Title of Change:	Update to FPCN22673X - Assembly and Test Capacity Expansion to Greatek (GTK) Taiwan for SSOT5 Products.	
Proposed First Ship date:	27 Jul 2020 or earlier if approved by customer	
Contact Information:	Contact your local ON Semiconductor Sales Office or Scott.Brow@onsemi.com	
PCN Samples Contact:	Contact your local ON Semiconductor Sales Office or <PCN.samples@onsemi.com>. Sample requests are to be submitted no later than 30 days from the date of first notification, Initial PCN or Final PCN, for this change. Samples delivery timing will be subject to request date, sample quantity and special customer packing/label requirements.	
Additional Reliability Data:	Contact your local ON Semiconductor Sales Office or Aileen.Allado@onsemi.com	
Type of Notification:	This is a Final Product/Process Change Notification (FPCN) sent to customers. FPCNs are issued 90 days prior to implementation of the change. ON Semiconductor will consider this change accepted, unless an inquiry is made in writing within 30 days of delivery of this notice. To do so, contact PCN.Support@onsemi.com

文書番号# : FPCN22673X1

発行日: 29 May 2020

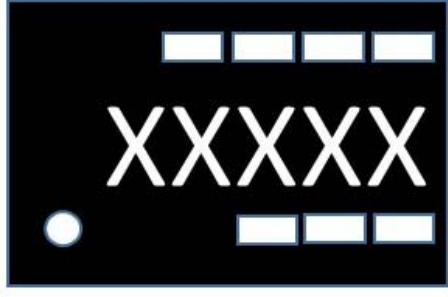
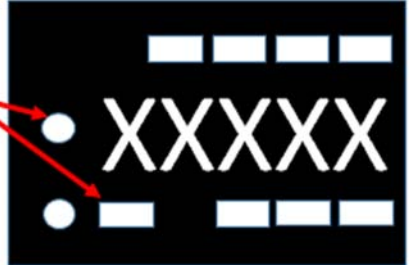
Marking of Parts/ Traceability of Change:	Product marked with date code 2030 or later may be built from current factory or from OSPI-Cebu factory. On the label of the box and reel, the ASSY LOC: D2 will also indicate product assembled in GTK. Please see sample label on Page 2 at the following URL http://www.onsemi.com/pub/Collateral/LABELRM-D.PDF to see the location of the ASSY LOC.	
Change Category:	Assembly Change, Test Change	
Change Sub-Category(s):	Material Change, Manufacturing Site Addition	
Sites Affected:		
ON Semiconductor Sites	External Foundry/Subcon Sites	
None	Greatek Electronics Inc., Taiwan	
Description and Purpose:		
This Update notification is to correct an error in FPCN22673X with regards to the marking differences between product out of Cebu, Philippines and the new assembly/test site at Greatek, Taiwan. Please see the correct marking shown here:		
Product marking change	Cebu (Current)  Where XXXX = Device Identifier	Greatek (New) Location Identifier  Where XXXX = Device Identifier

Cebu(現行)	Greatek(新規)
製品マーキング変更	 <p>Where XXXX = Device Identifier</p>	 <p>Where XXXX = Device Identifier</p>

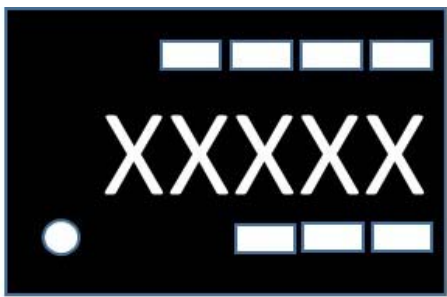
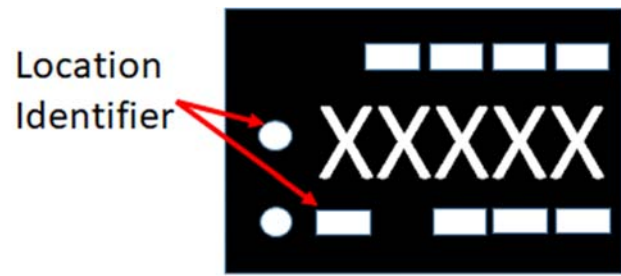
本更新通知は、セブ(フィリピン)と新しい組立/検査拠点である Greatek Taiwan からの製品間に存在するマーキングの違いに関して、FPCN22673X における間違いを修正するものです。正しいマーキングは次を参照してください。
